# MILLWARD STREET APARTMENTS

DEVELOPMENT PLAN RESUBMISSION

Re: Development Plan: 245 & 265 Millward Street

## P22-253 Dev. Plan Project Reviews

**L0.3**

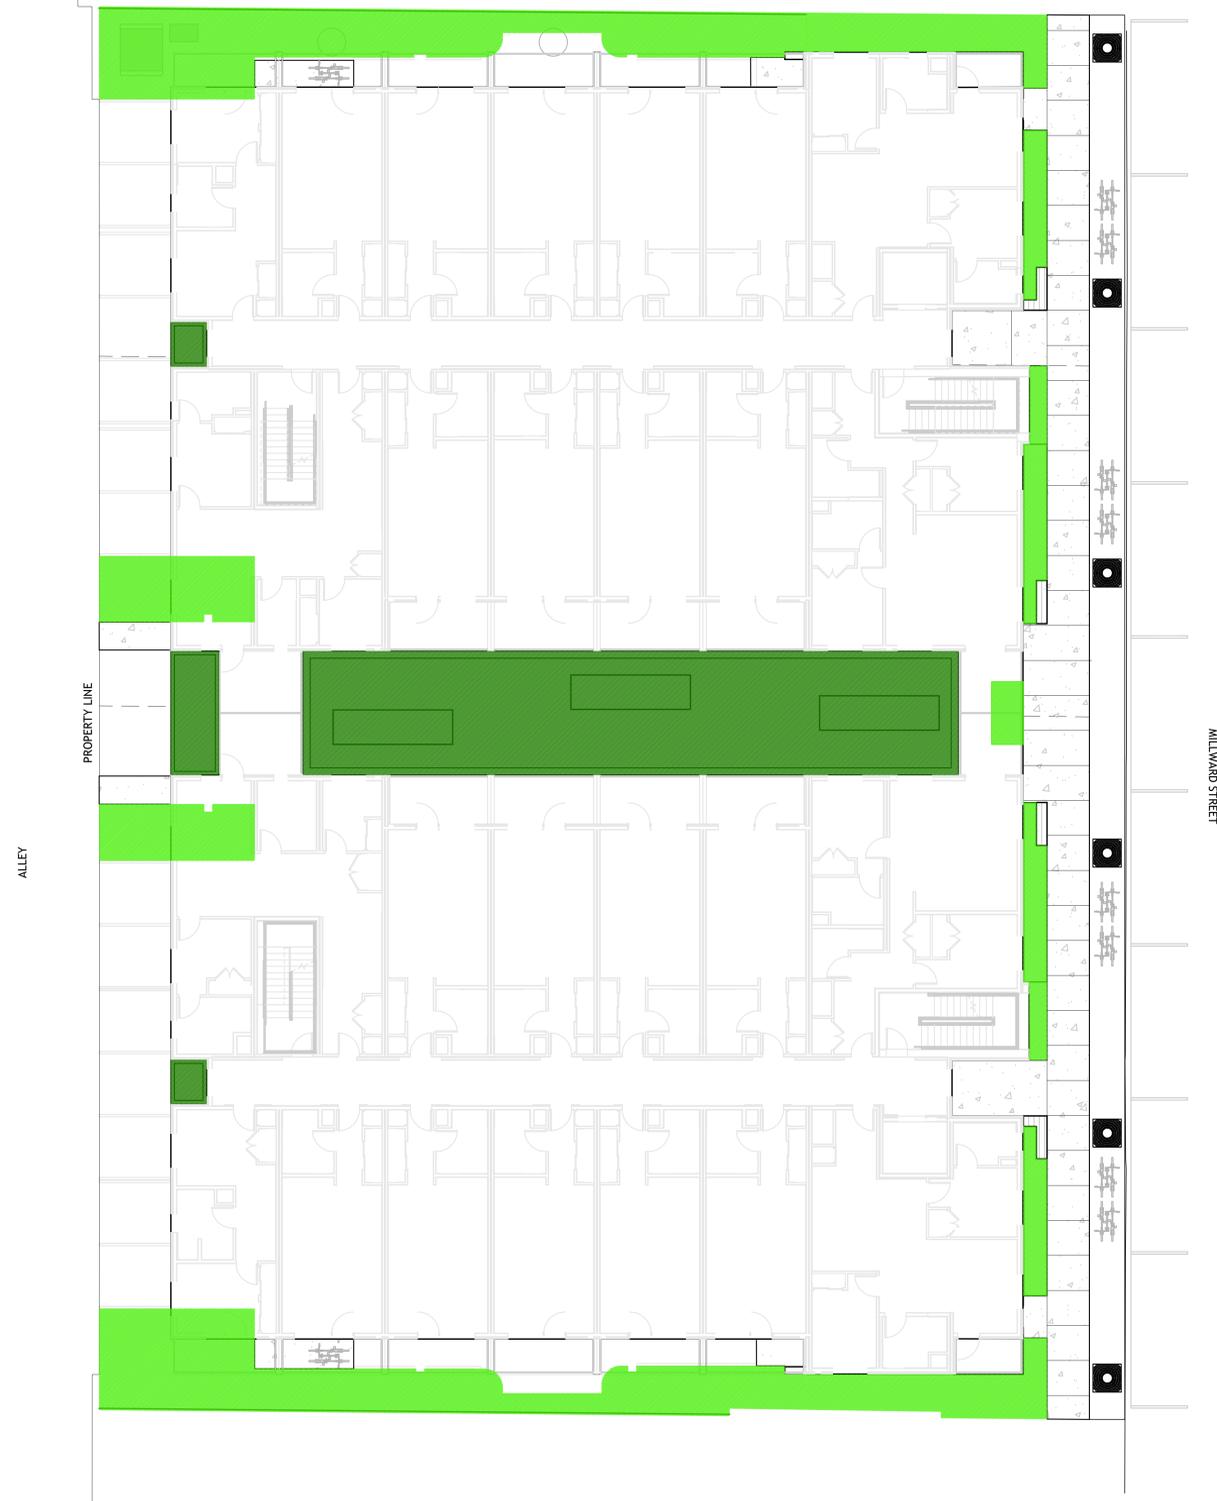
- Provide "native shrub" selection for Millward streetscape. Plant Species have been added to L0.3 and L4.0.
- Would like to see a tree pit detail. TOJ standard tree pit detail has been added to L5.1.
- Notification of clearance requirements for 5' wide clear zone on sidewalks and potential impacts/trimming requirements of species selection. Sidewalk shown on all sheets have been updated to comply with TOJ standards. Shrubs and perennials are set back against building in raised planters and should not impact clear zone.

- Planning Dept. highly suggests incorporating screening between the parking facility and side property lines. Consider fencing or landscaping options. **Planted areas have been extended along the north and south property lines, as shown in A1.01 and L0.3 and L4.0.**

- LSR calculations (L0.6) appear to be calculated off “proposed structures” instead of Gross Site Area. Revise LSR calcs to base off gross site area. **Correct LSR calculations have been provided on L0.3, L0.4 and L4.0.**
- Landscape plan and LSR calcs will need to update to accommodate wider sidewalk and furnishing area required by “Trees-in-grates”. **All site plans have been updated to reflect the TOJ sidewalk and furnishing requirements for trees in grates.**
- Check landscape and site plans for consistency. Landscaping shown on landscape plans near alley corners but not shown on site plan. **Site and landscaping plans have been coordinated.**

- Pedestrian Frontage – Sec. 2.2.1.C.2 Trees in grates – Revise plans to show required dimensions for sidewalk and hardscape minimums. Trees in grates requires planting area of min 5' width (4' is shown) and clear sidewalk min of 6' (5'-4 1/16" is shown). Back of curb 13.5' is met. Note: landscape plan will need to update to reflect these changes and LSR calcs. **Site plans have been updated to reflect the Trees in Grates Requirements for pedestrian frontage. Updated LSR calcs have been provided on L0.3, L0.4 and L4.0.**

Project Millard Street Apartments	
245 & 265 N. Millard St., Jackson, WY 83001	
2210	Project No. 22-020-02
Drawer	Drawn By BRADEN OLSON
Checker	Checked By JOSH KILPATRICK
Discipline	Drawing No.
<b>C3.1</b>	
Drawing Name POWER SITE PLAN

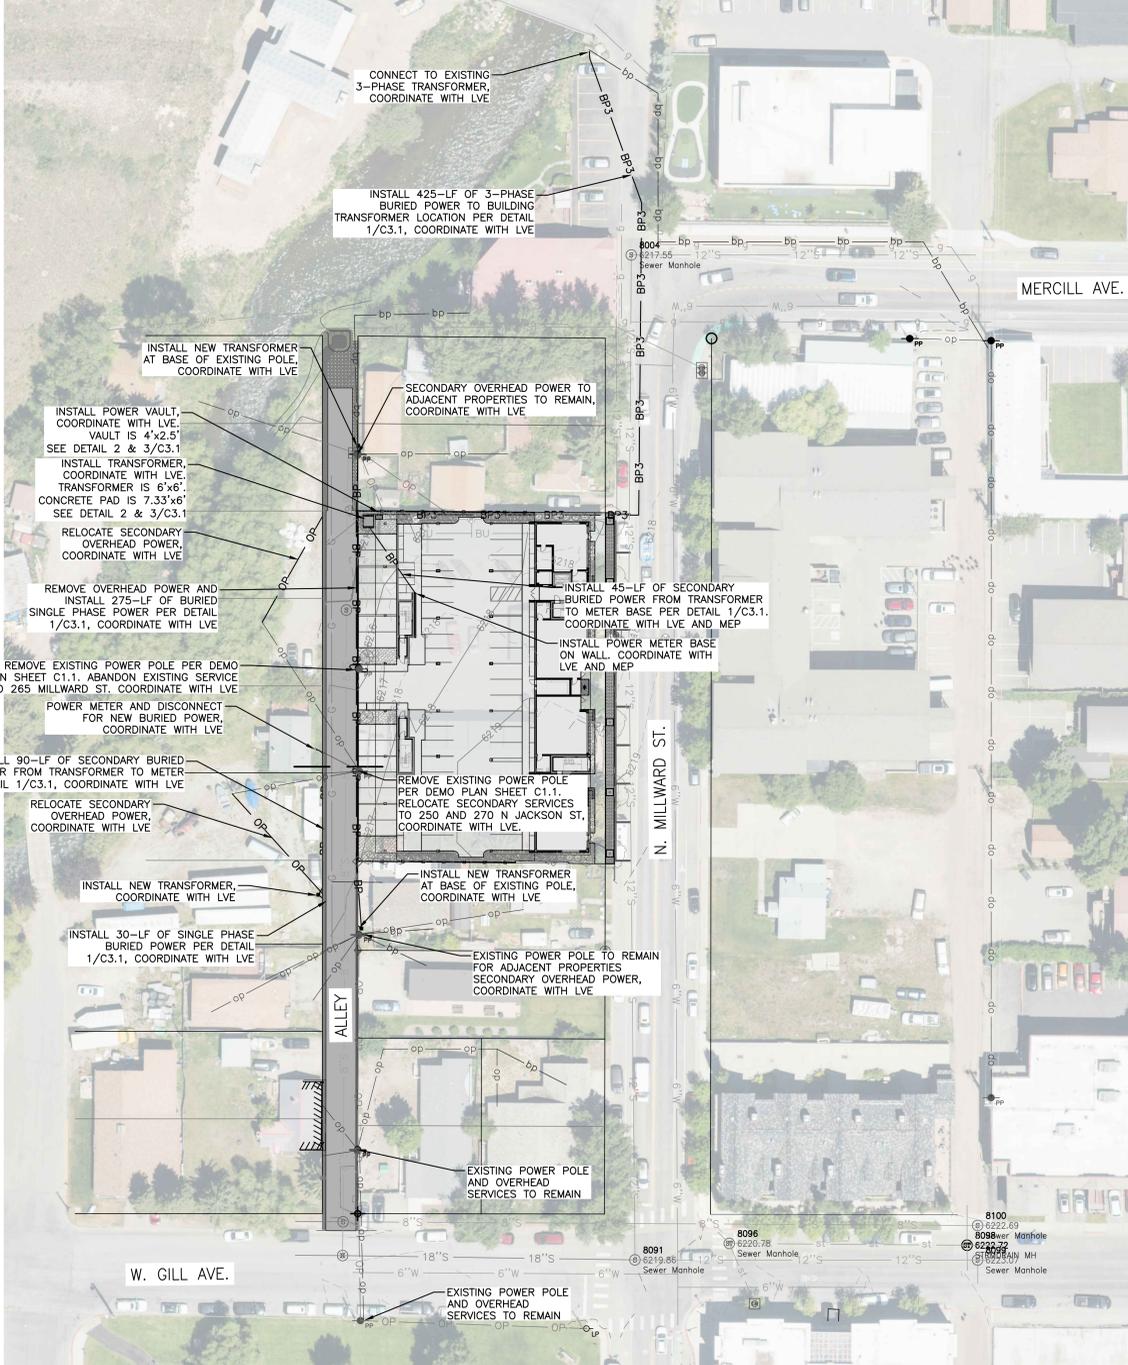
- Transformer door may not swing into the alley right of way. Planning / Engineering may require at least a 2' setback to accommodate access. **Transformer location was revised for transformer door to not swing into alley. Items were coordinated with LVE. The transformer is set back 3' from the alley and 2' from the north property line.**

Project Millward Street Apartments	
245 & 265 N. Millward St., Jackson, WY 83001	
2210	Project No. 22-020-02
Drawer	Drawn By BRADEN OLSON
Checker	Checked By JOSH KILPATRICK
Discipline	Drawing No.
<b>C4.0</b>	
Drawing Name GRADING AND EROSION CONTROL PLAN

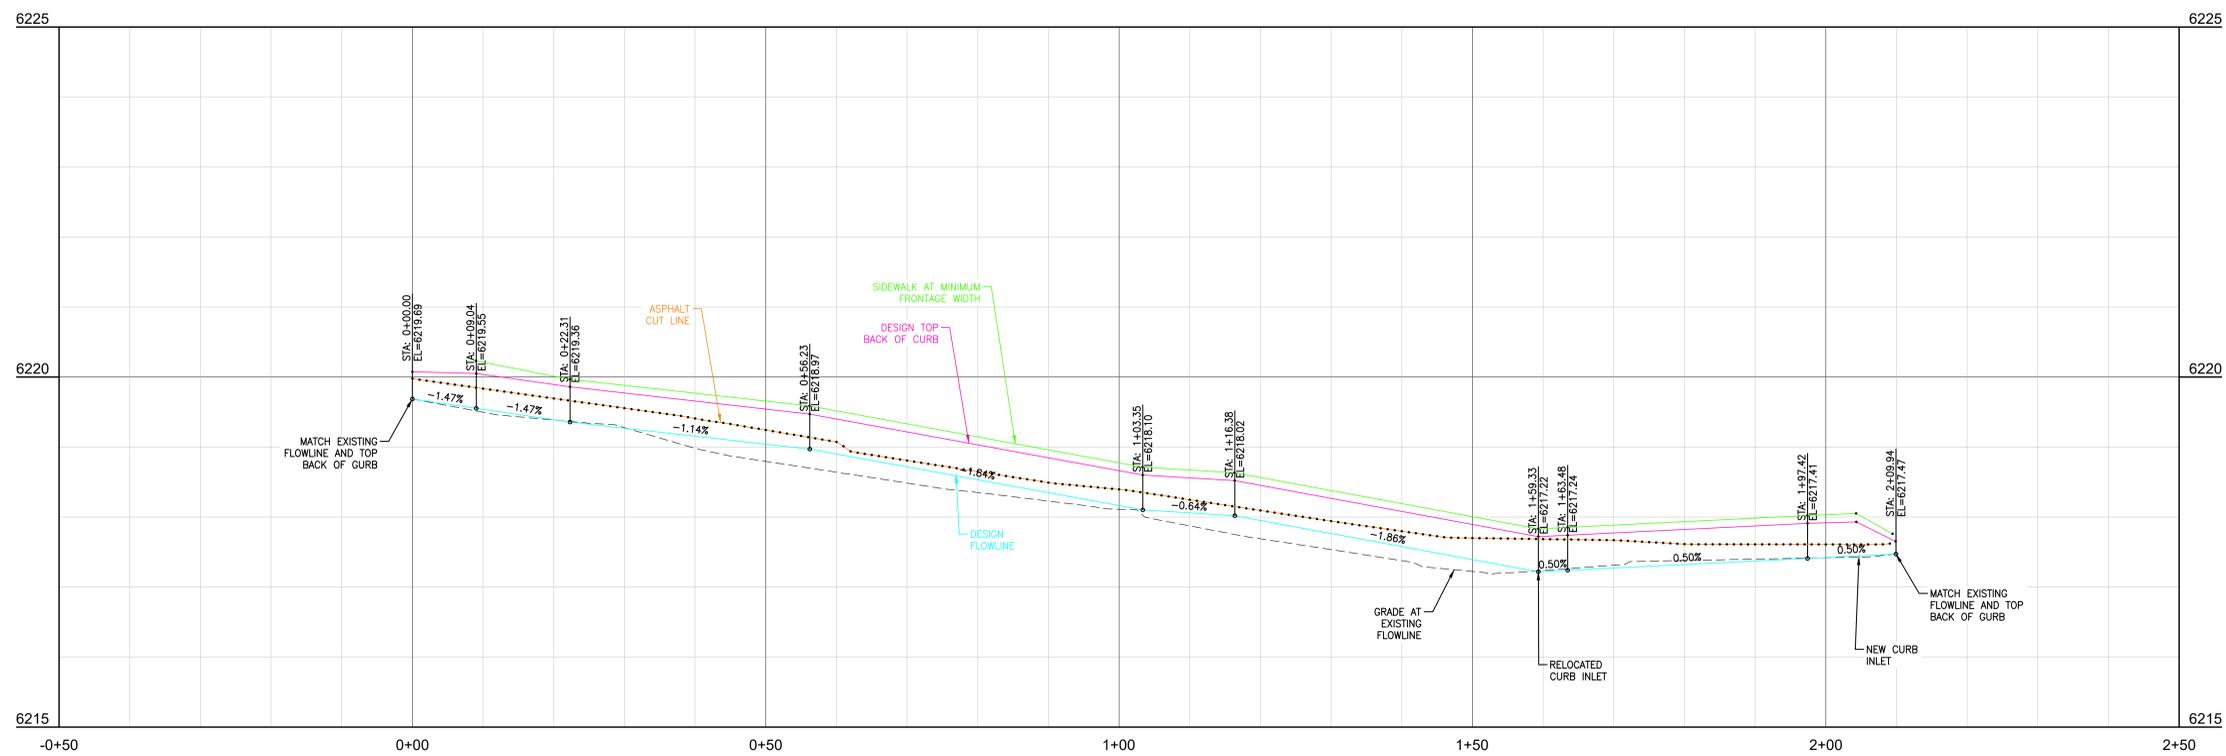
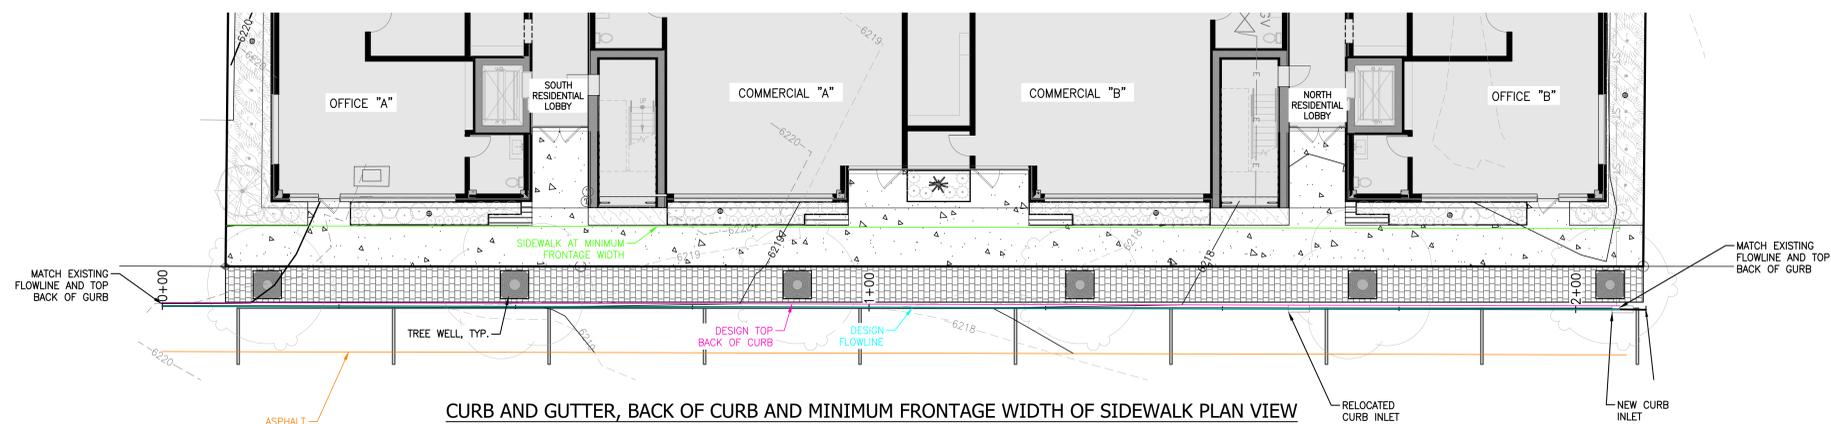
5.7.2 Grading Standards: Provide a grading plan that shows compliance with this section. Plan shall include existing and proposed site contours with elevation labels, spot elevations, high and low points, grade breaks. **See sheets C4.0-C4.2 for grading plans meeting ToJ Code 5.7.2-5.7.3.**

5.7.3 Erosion Control Standards: Provide an erosion control plan that shows compliance with this section. **See sheets C4.0-C4.2 for grading plans meeting ToJ Code 5.7.2-5.7.3.**

Project Millward Street Apartments	
245 & 265 N. Millward St., Jackson, WY 83001	
2210	Project No. 22-020-02
Drawer	Drawn By BRADEN OLSON
Checker	Checked By JOSH KILPATRICK
Discipline	Drawing No.
<b>C4.3</b>	
Drawing Name ALLEY DEVELOPMENT PLAN

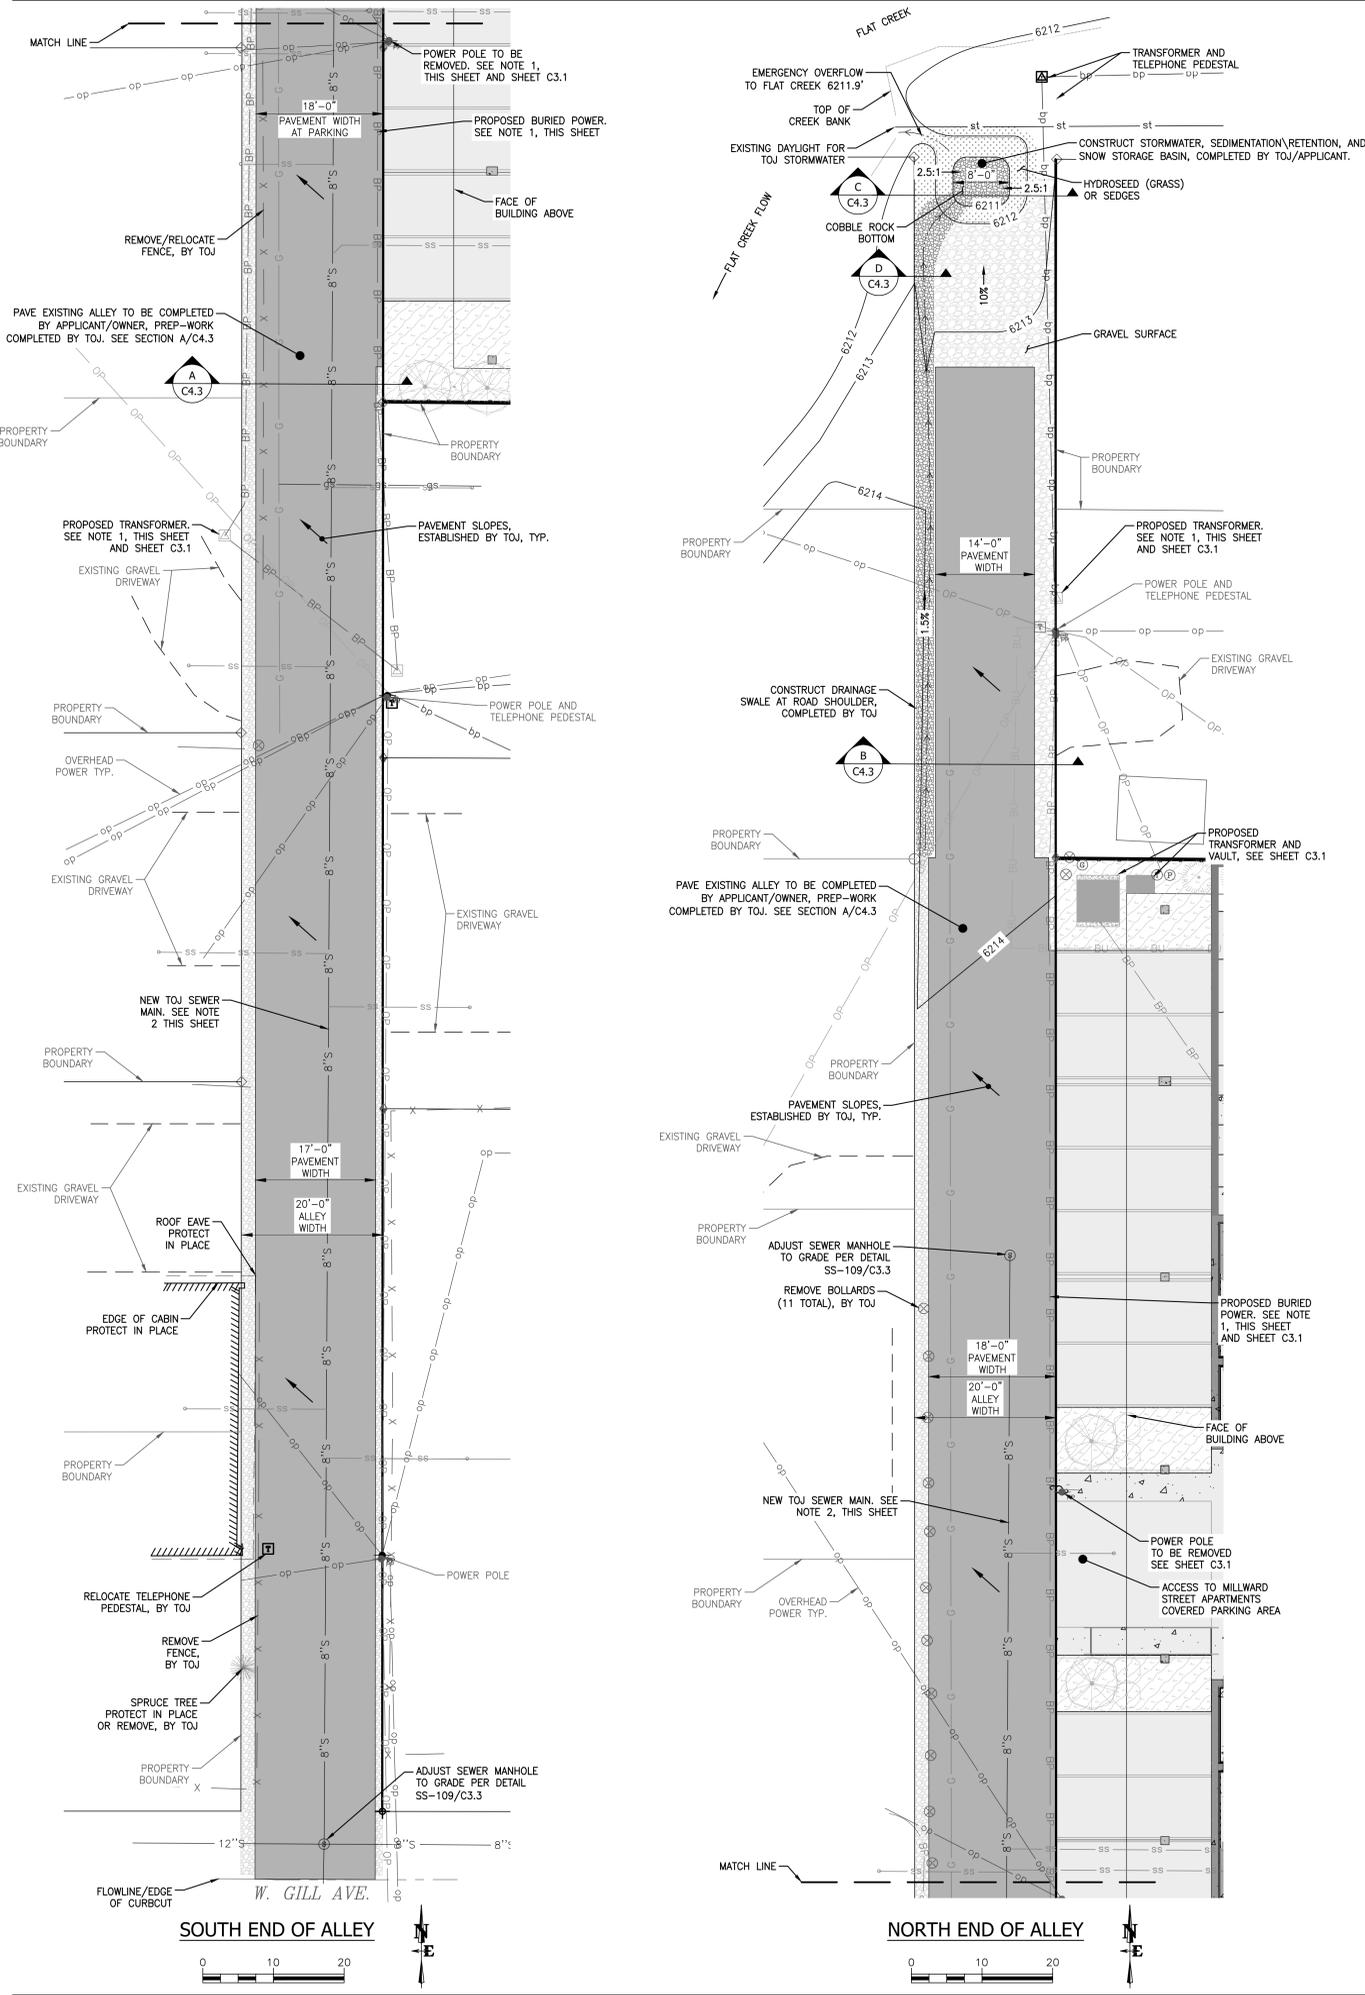
- P.92-93 (C4.3, Existing Alley Survey) – **Proposed and existing alley site plans were drawn, and a new stormwater retention strategy was proposed.**  
The alley and its existing encroachments have been surveyed. Excess stormwater is being retained pre-post on site.
